ADDENDUM NO. 2

**NEAR-TERM WATER IMPROVEMENTS
PROJECT NO. 24171 & 24173**

UTILITY UNDERCROSSING DETAIL 3 VAR
NTS

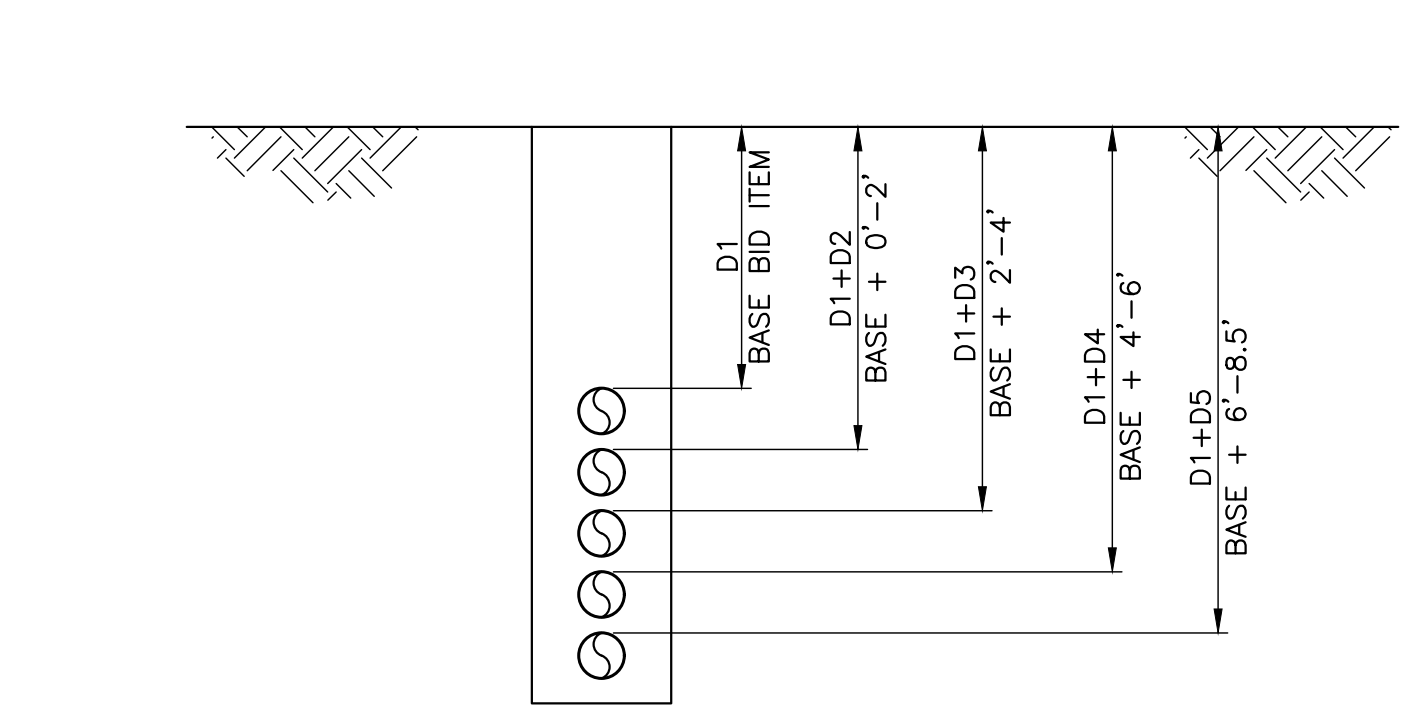
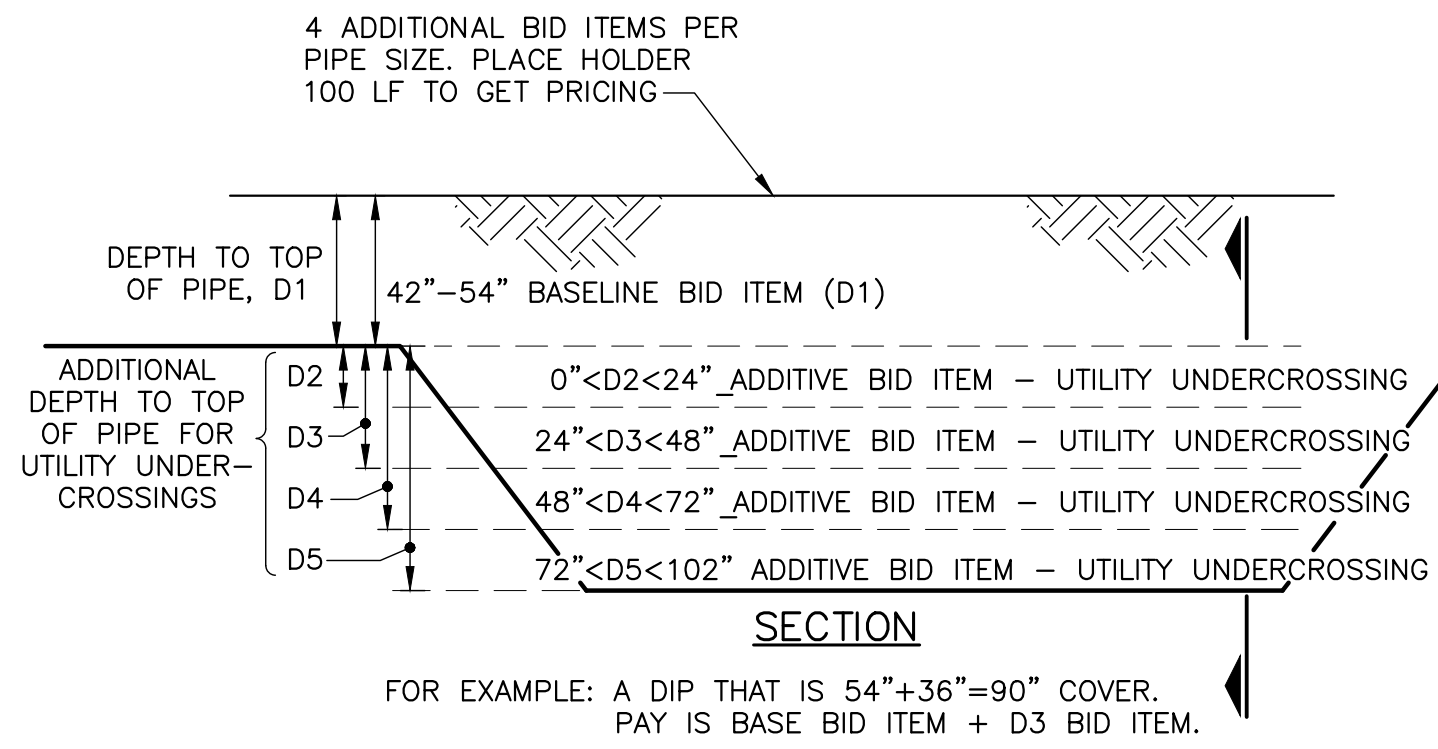
Undercrossing Details 2 & 3 have been revised to clarify "TR Flex or HDSS pipe with TR Flex fittings or Approved Equals" are required.
